From: Chowdhury, Prosanta
Sent: Monday, October 29, 2012 10:16 AM
To: 'PSEGRAIResponses@pseg.com'
Cc: PSEGSPeRAIPEm Resource; 'James.Mallon@pseg.com'; 'David.Robillard@pseg.com'; Segala, John; Roach, Kevin; Clark, Phyllis; McLellan, Judith; Jones, Henry; Caverly, Jill
Subject: PSEG Site ESPA FINAL RAI 67 (eRAI 6615) SRP-02.04.05 (RHMB)
Attachments: PSEG Site ESPA Final RAI 67 (eRAI 6615).pdf

Request for Additional Information 67

PSEG Site ESP

Review Section: 02.04.05 - Probable Maximum Surge and Seiche Flooding

Screen Shots from HEC-RAS model results

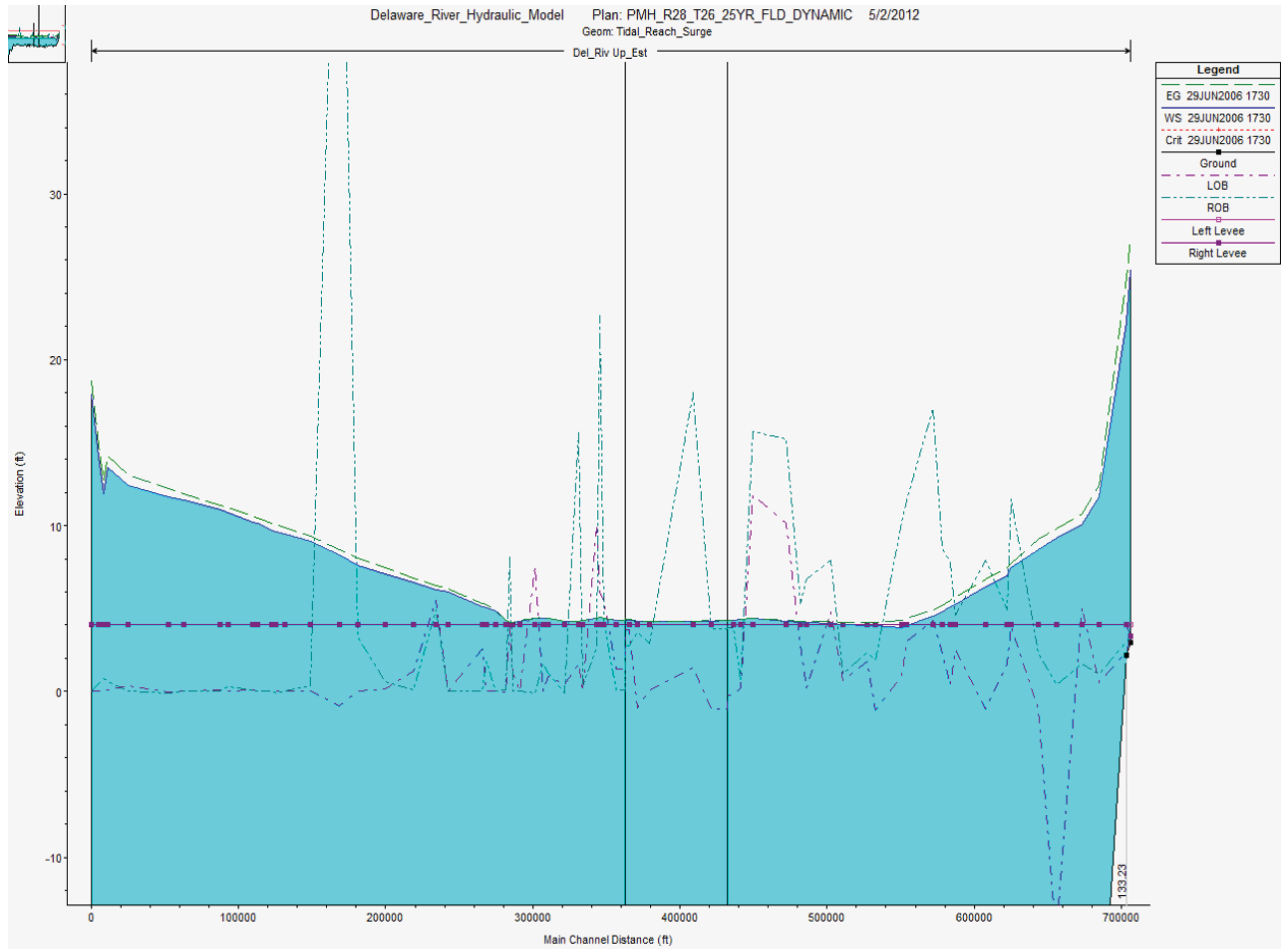
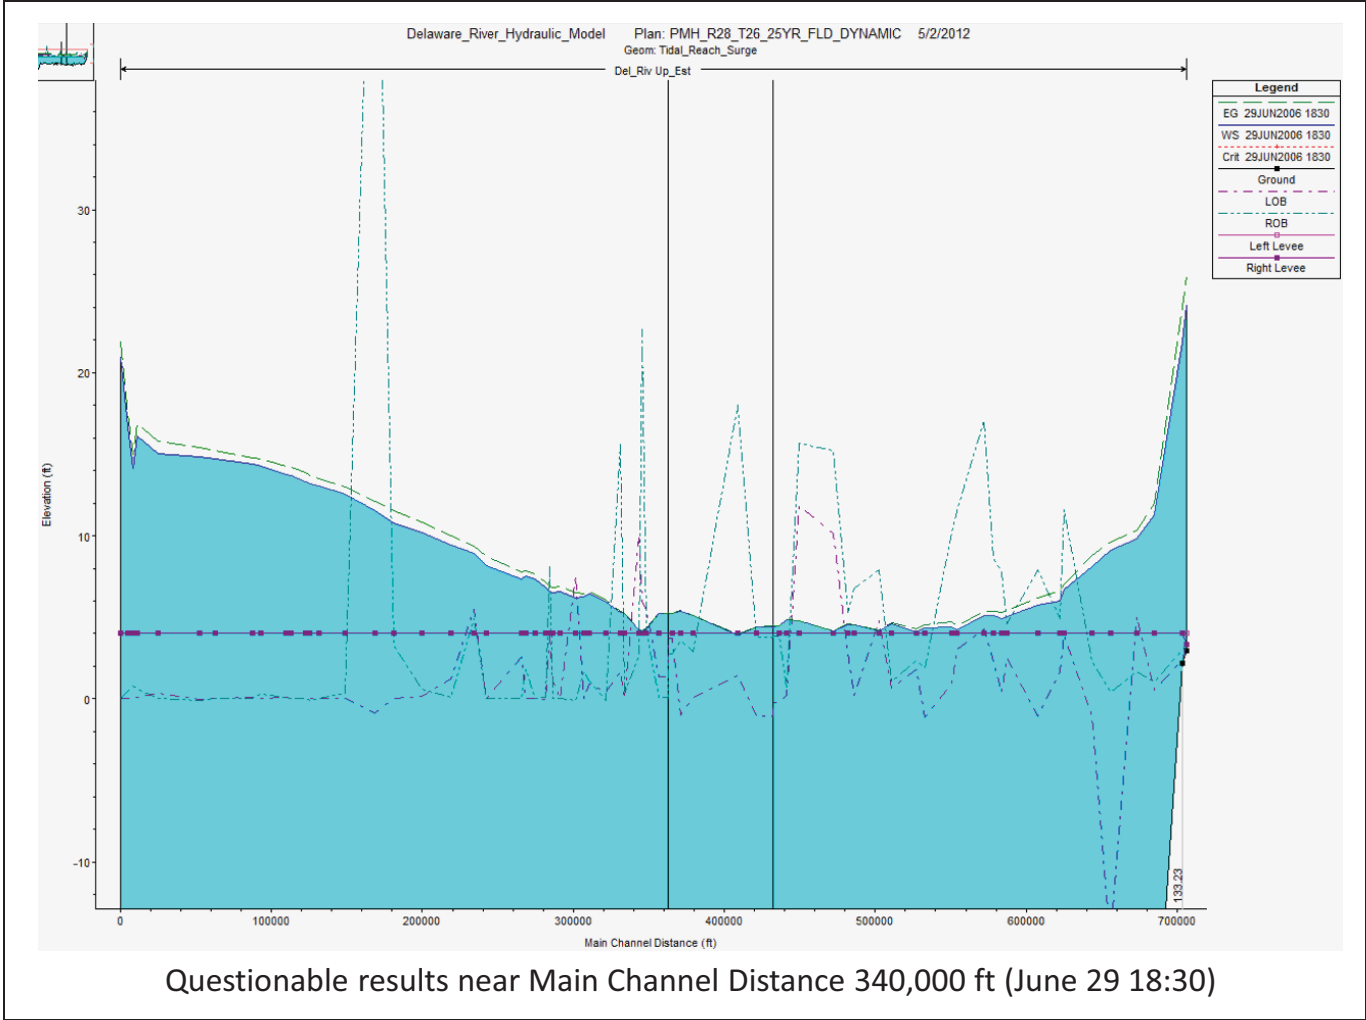
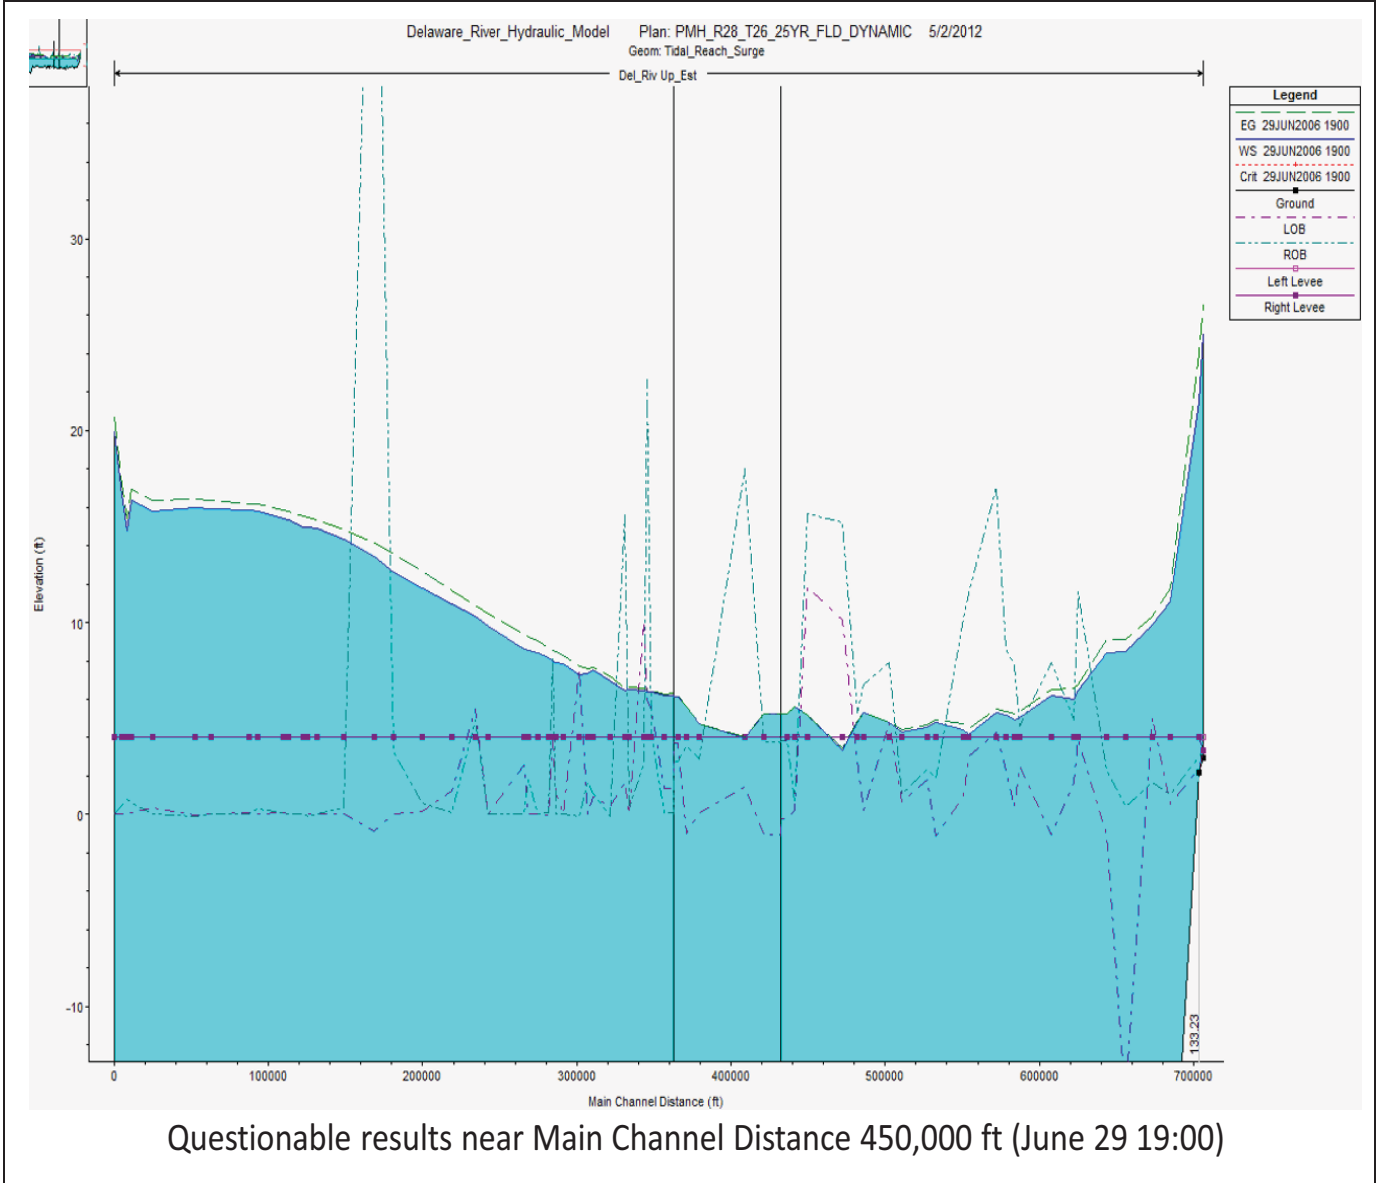
The PSEG animation of the longitudinal water surface profile appears to indicate model numerical instability during the simulation. The instability appears very pronounced just before the passing of the peak surge wave for the PMH surge run (as presented in the HEC-RAS Model run screen shots pasted below). In order to show compliance with the requirements of 10 CFR 52.17 and evaluate the methods applied, the NRC staff requests that PSEG describe any steps taken steps to minimize the model instabilities. If steps were taken to reduce model instabilities, please describe how these steps affected the model results.

- Screen shots from the animation of the longitudinal water surface
 - Applied data from PSEG provided output file for the Plan “PMH_R28_T26_25Yr_FLD_DYNAMIC”
- Screen shots show possible model instability near boundary and in the middle of the model (near project area)

Questionable results near Main Channel Distance 0 to 10,000 ft (June 29 17:30)
